COUNCIL ASSESSMENT REPORT

SYDNEY EASTERN CITY PLANNING PANEL

Panel Reference	PPSEC-273
DA Number	DA-2023/106
LGA	Bayside Council
Proposed Development	Integrated Development - Amalgamation of lots, demolition of existing structures, and construction of a ten (10) storey mixed-use building containing a childcare centre with capacity for 96 children, operating 7:00am to 6:00pm Monday to Friday and eighty-eight (88) residential apartments, communal and private roof top terraces and basement parking
Street Address	594-600 Princes Highway, Rockdale
Applicant/Owner	<u>Applicant</u> : Fuse Architecture Pty Ltd <u>Owner</u> : The Trustee for Chandru Property Unit Trust No 5
Date of DA lodgment	8 May 2023
Number of Submissions	7 in total: 4 (in the first round) and 3 (in the second round)
Recommendation	Approval, subject to conditions.
Regional Development Criteria (Schedule 7 of the SEPP (State and Regional Development) 2011)	Private infrastructure over \$30 million (Nominated CIV: \$38,269,781)

Figure 8: Western elevation [supplied by applicant] – to be amended to include additional glazing at ground level and include other minor changes as per the Design Review Panel.

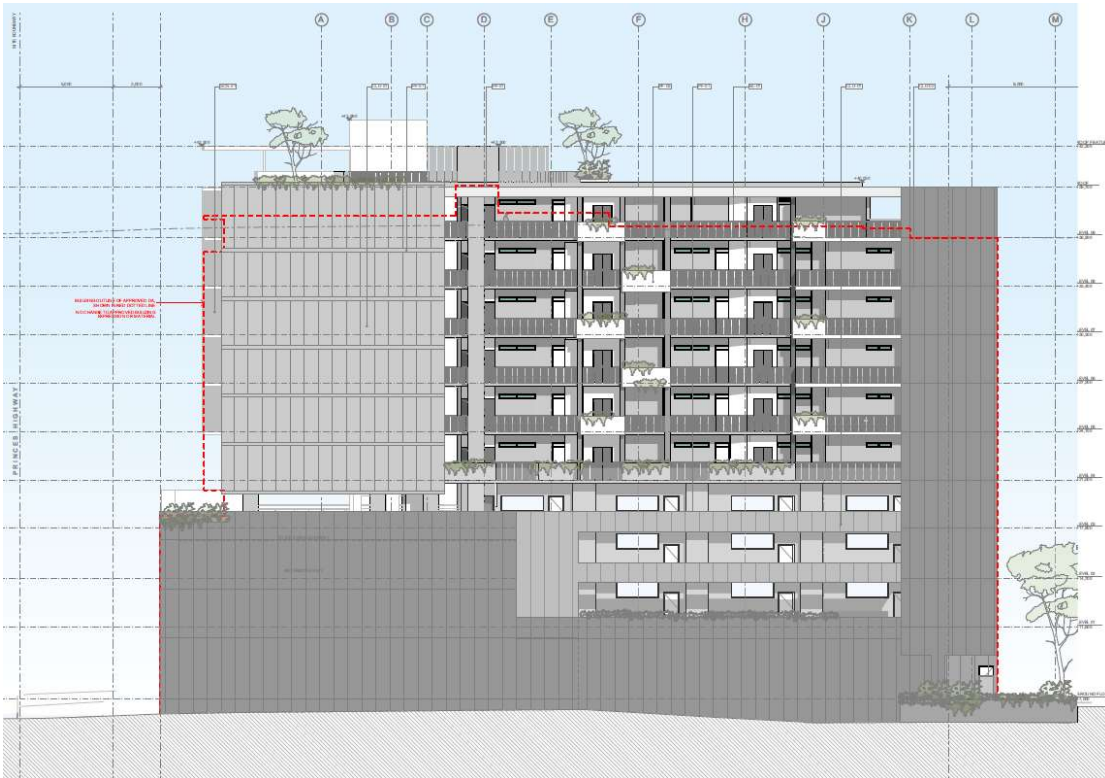
- Western podium façade can be further developed with more modulation and articulation defining the bays. This includes further refinement of the building materiality (as described in aesthetics) and
- Configuration of air conditioning (A/C units) and their integration into the façade needs further consideration to avoid heat load being added to wintergardens.

- Additional glazing at ground floor (for the staff room only) to allow for additional surveillance;
- Screens to be moved outside of the balustrade;
- Frames to be concrete for articulation; and
- A/C units to be relocated with details to be provided by way of amended plans.

Figure 12: Section showing extent of variation (thinner red dotted line) [supplied by applicant]

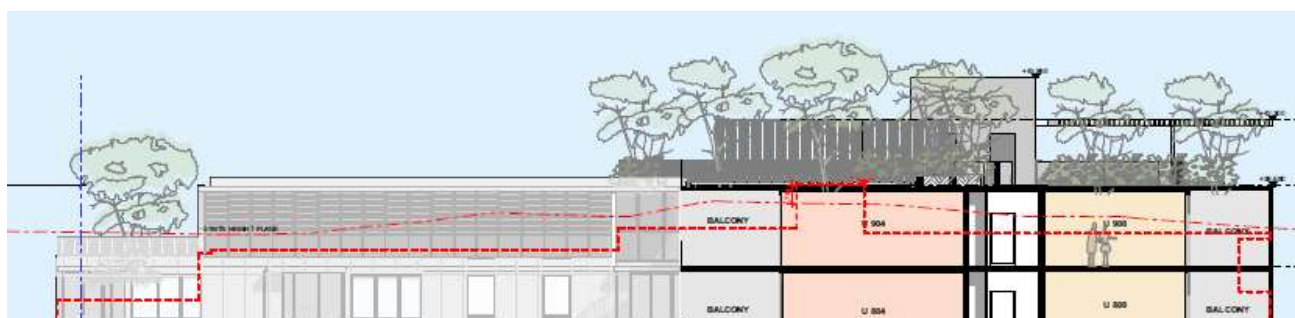
The applicant is seeking to contravene the Building Height development standard by 6.25 metres to the top of the lift overrun which equates to a 20.16% variation. A contravention request in accordance with Clause 4.6 of the LEP, seeking to justify the proposed contravention, has been

- All habitable floor levels generally contained within the 31m height plane. The exceedance will have no measurable impact on the natural and built environment and will be barely perceptible from the public domain or adjoining properties.
